## Appendix 8

Reference: 190509.01FC

### LETTER OF ADVICE OF PROPOSED RESOURCE RECOVERY FACILITY AT 7 MONTORE ROAD, MINTO

Reference is made to your request to provide Letter of Advice for the Proposed Resource Recovery Facility at 7 Montore Road, Minto (Concept Site layout in **Annexure A**). This letter addresses comments from the Department of Planning in reference to *M<sup>C</sup>Laren Traffic Engineering's (MTE) Traffic and Parking Impact Assessment (TPIA)* dated 5<sup>th</sup> February 2019 (ref 18259.01FB). The Department comments are quoted below followed by **MTE's** responses.

**FIGURE 1: EXISTING SITE DRIVEWAY CONDITIONS**

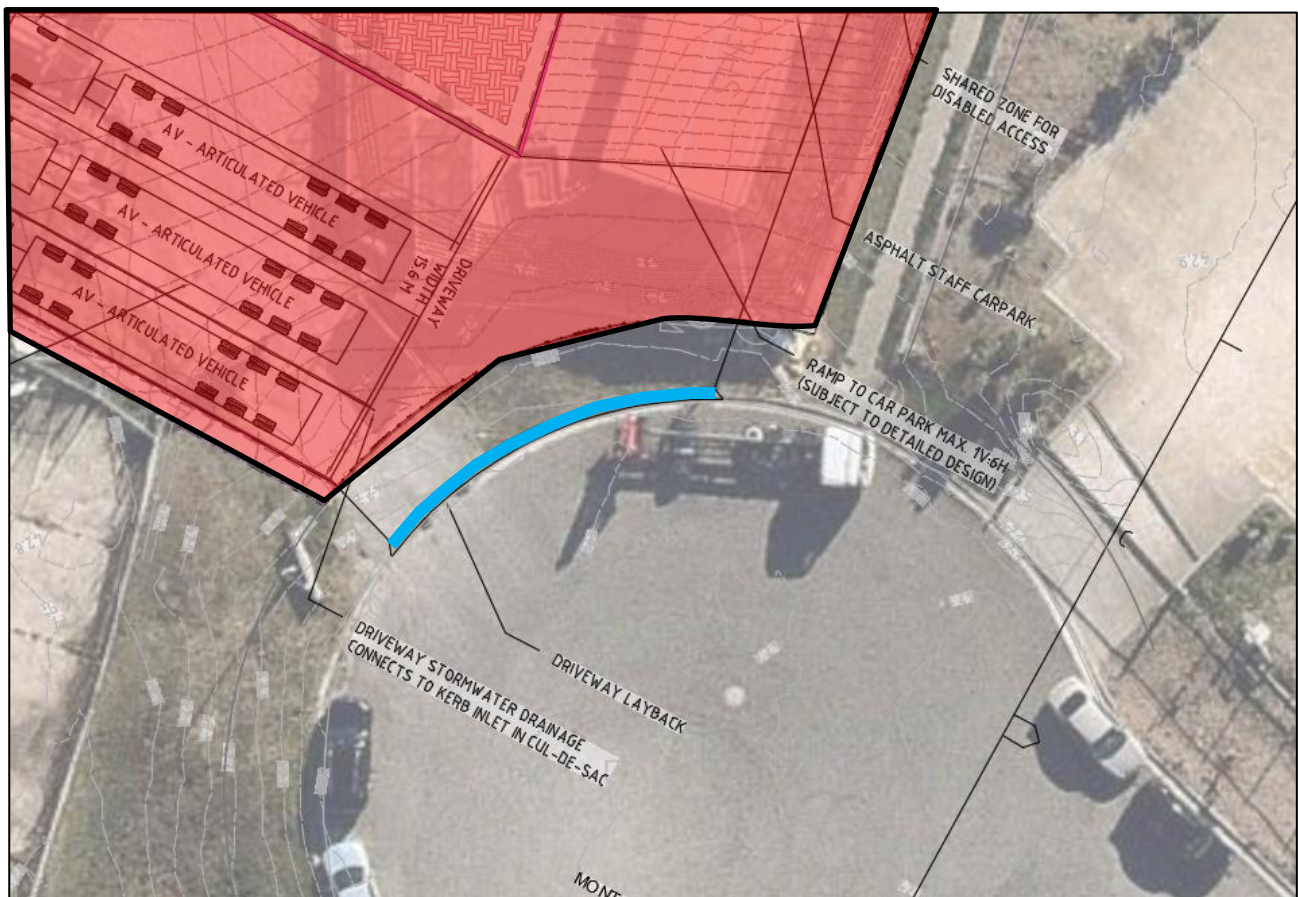
*Describe the site access, will it be upgraded?*

**MTE Response:** The site access is shown in the plans in **Annexure A**. The proposal requires a significantly wider layback than what is provided on the existing site. The singular layback will provide access and egress to both the weighbridge for AV's and the car park for passenger vehicles. The existing and proposed laybacks are compared in **Figure 1** and **Figure 2** below. Additionally, the original TPIA, dated 5<sup>th</sup> February 2019, has been updated to include these figures.

**FIGURE 3: AS2890.2:2018 – SIGHT DISTANCE REQUIREMENTS AT ACCESS DRIVEWAY EXITS**

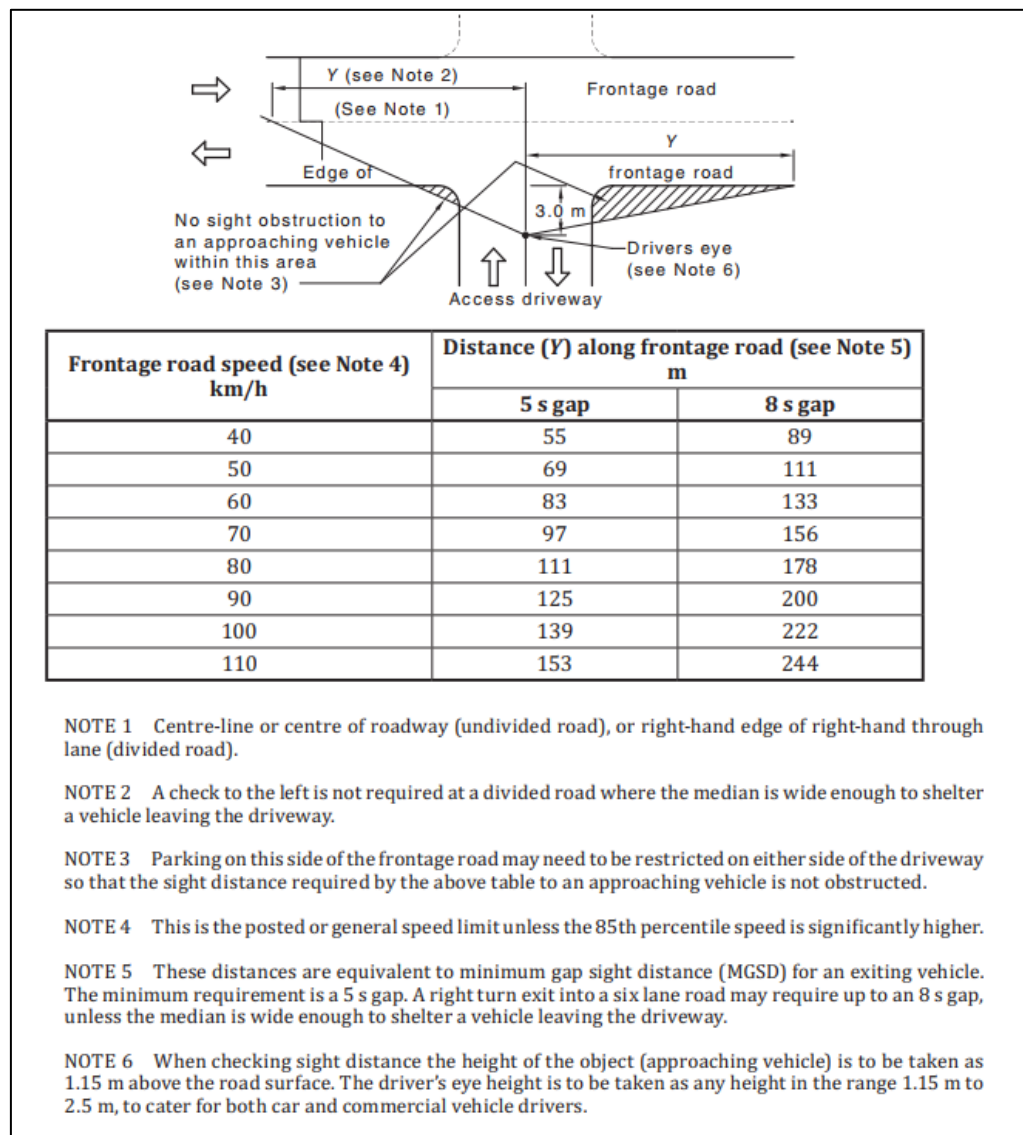
Assess impacts on safety of the surrounding road network.

**MTE Response:** Montore Road is 50km/h road and the site access is proposed via a two-way driveway from a cul-de-sac. The geometry of the road and the proposed location of the driveway would result in vehicles passing the site at a speed lower than the speed limit of 50km/h. Regardless, the sight line of the driveway has been assessed against the requirements of a 50km/h road under AS2890.2:2018. The minimum sight line required is a 5s gap along the frontage road which corresponds to a distance of 69m as detailed in Figure 3.3 of AS2890.2:2018 and reproduced in **Figure 3** below.

**ANNEXURE A: PLANS**  
**(SHEET 1 OF 3)**

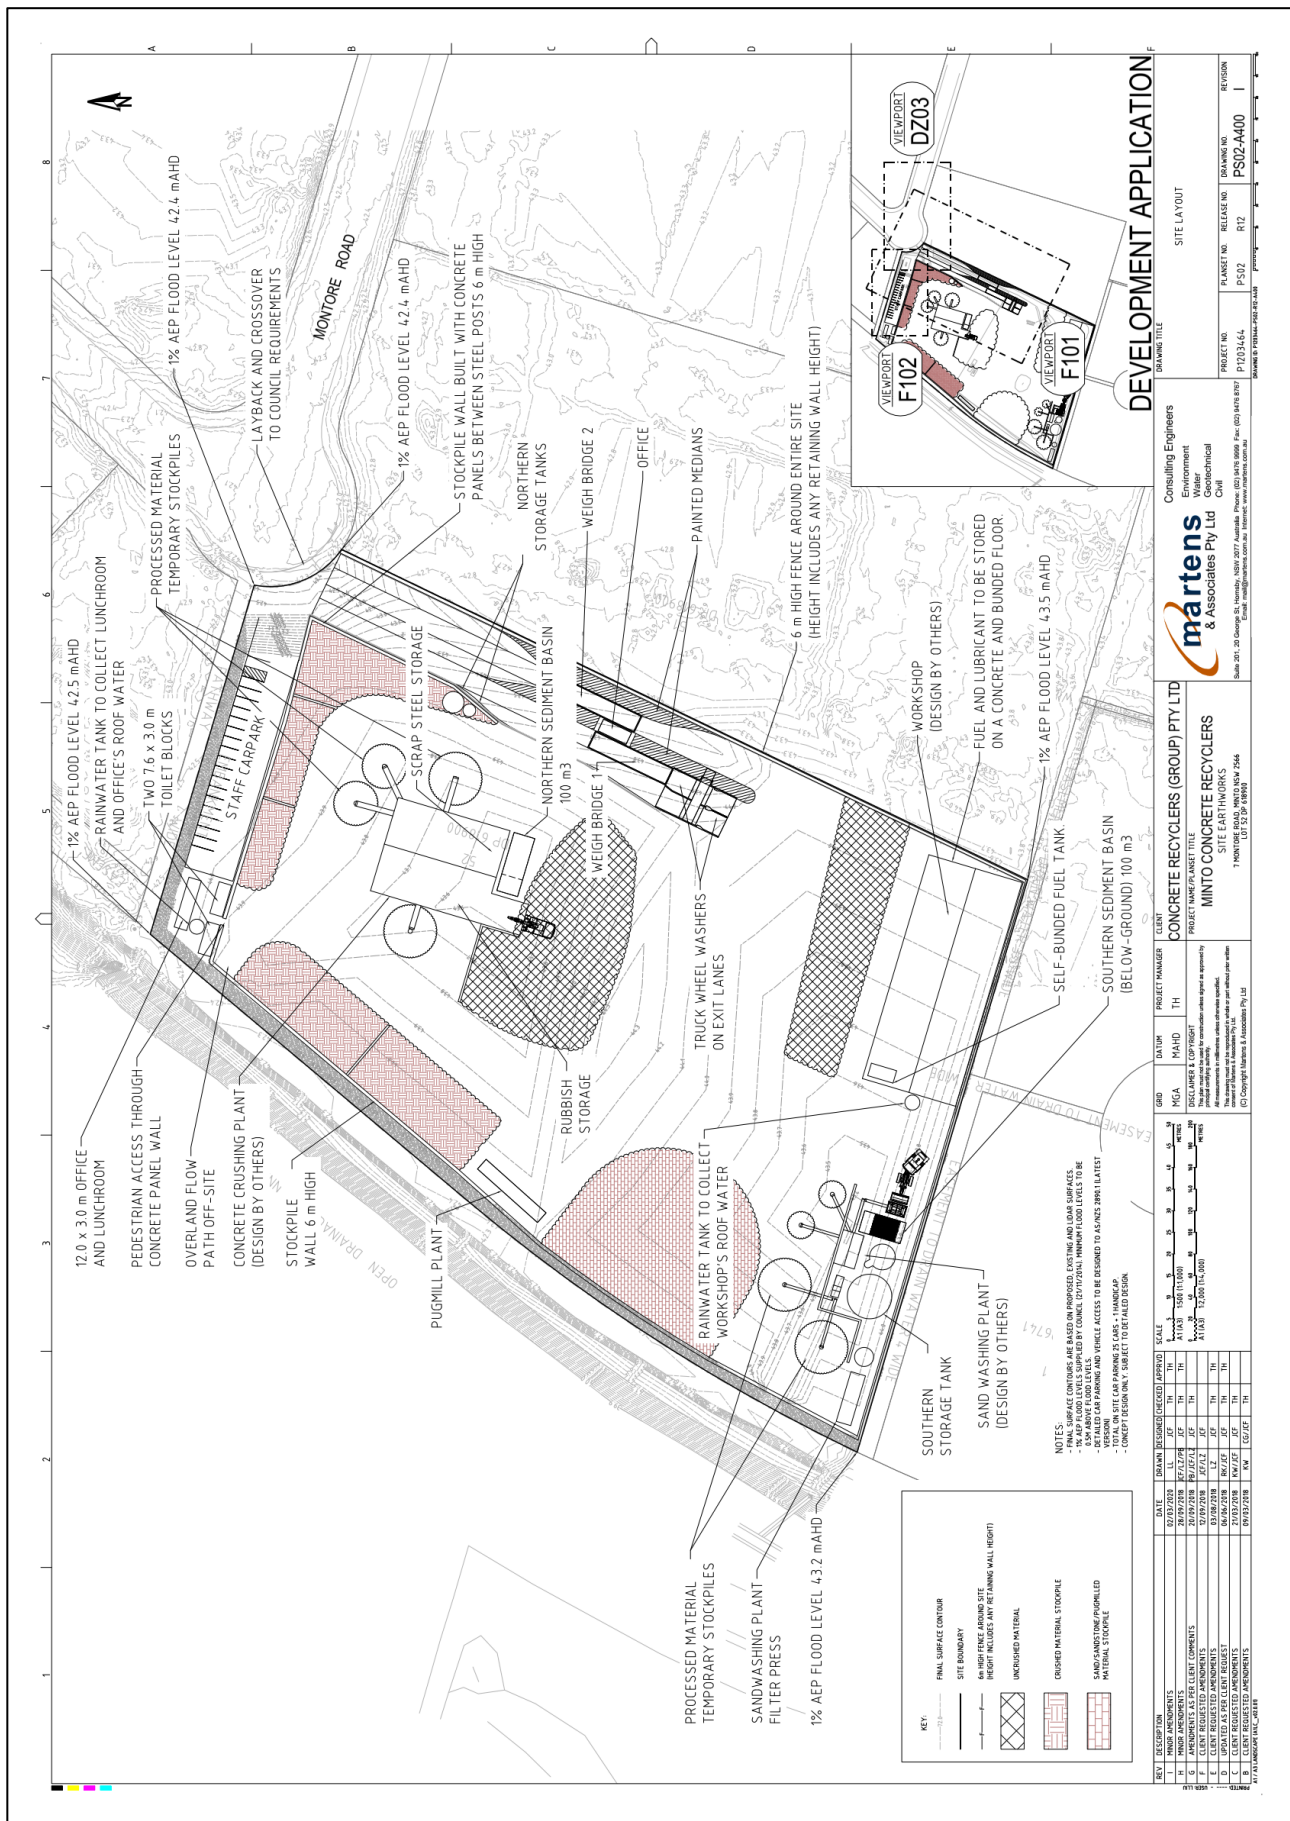
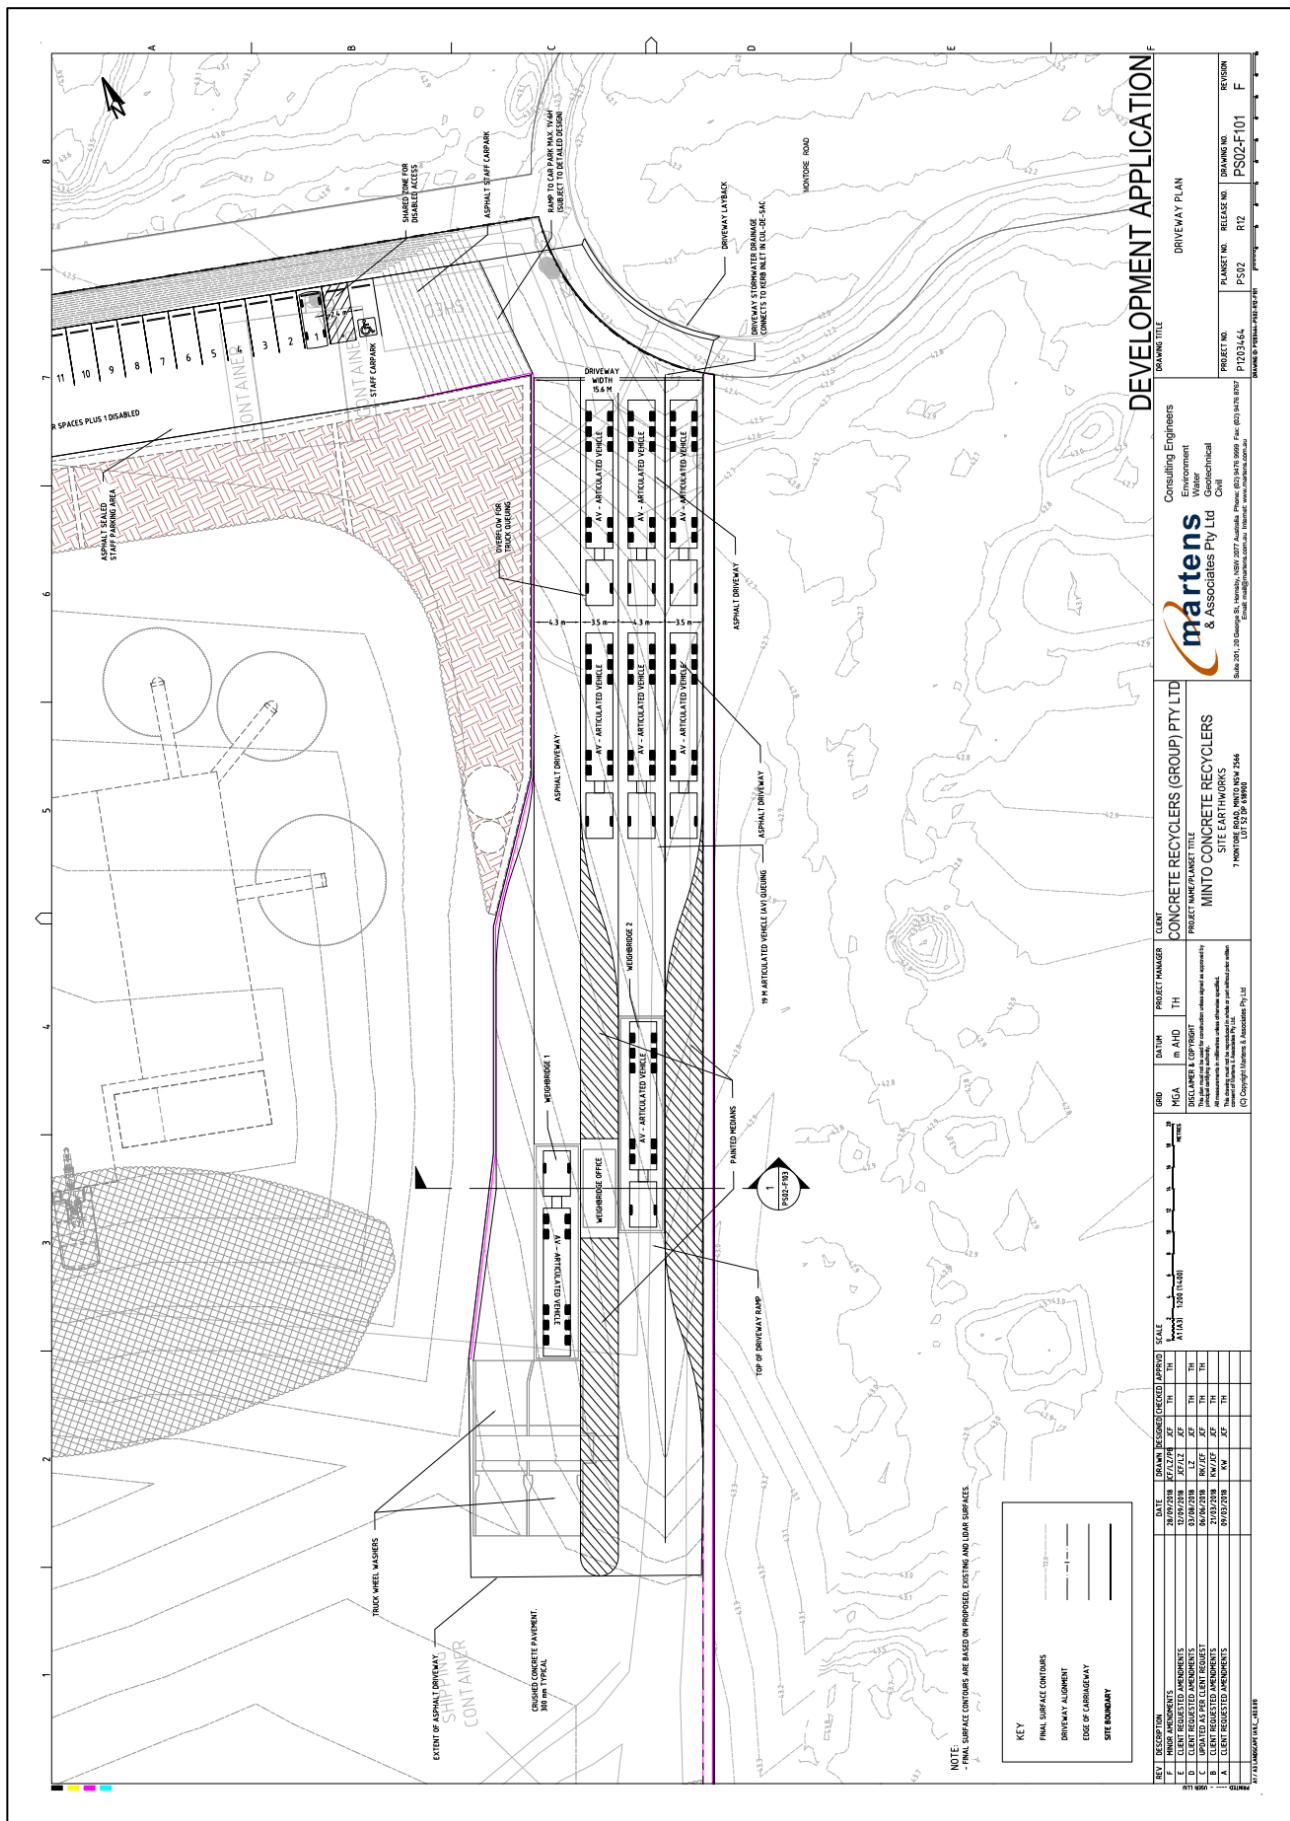
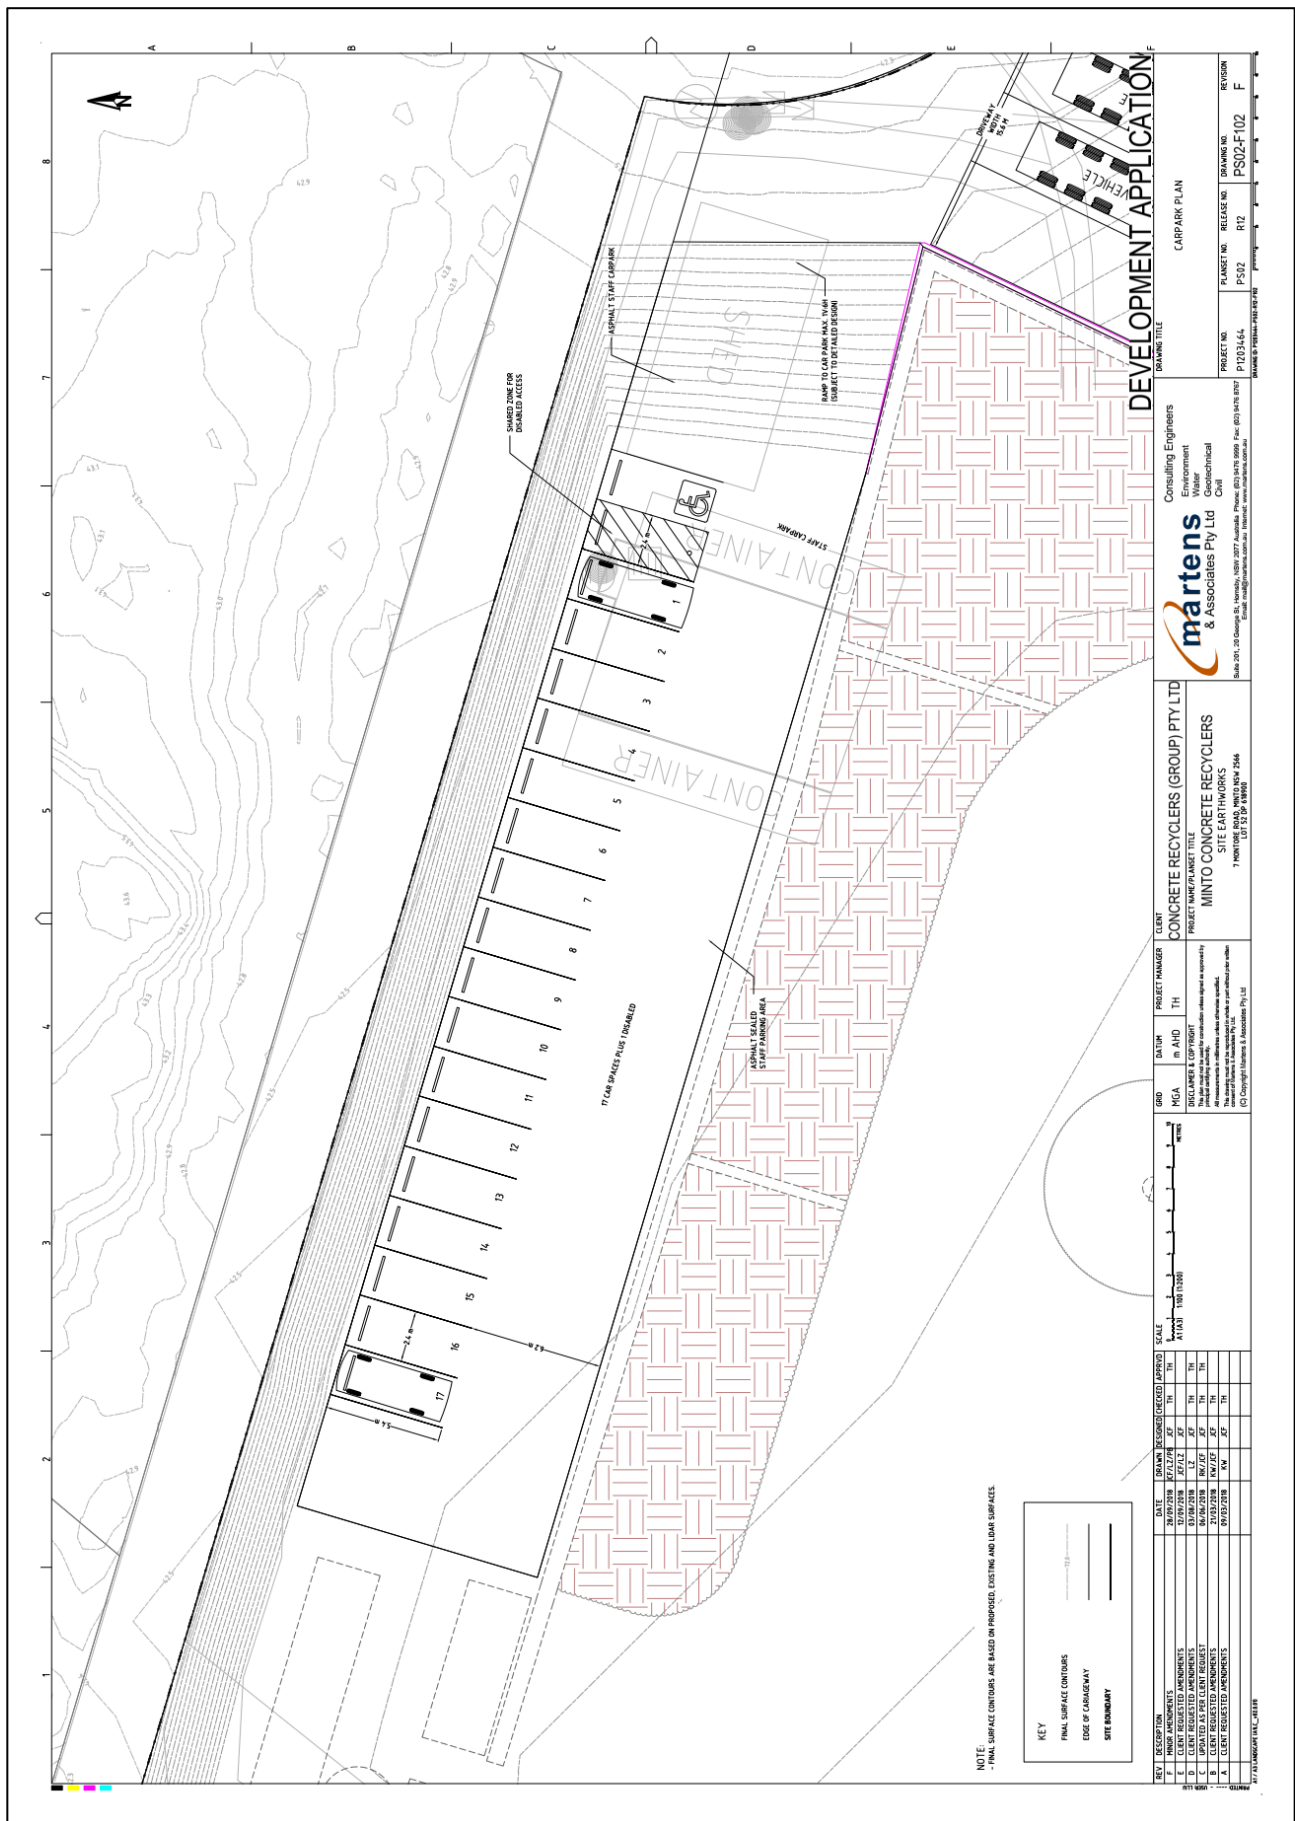
*Show the waiting bays on a plan*

**MTE Response:** The truck waiting bays are shown on the plans in **Annexure A**. The waiting areas are large enough to accommodate six (6) AV's prior to the weighbridge. As discussed above it is not expected that any waiting areas will be required for loading or unloading operations within the site. Regardless, there is sufficient area internally to accommodate trucks waiting within the site.
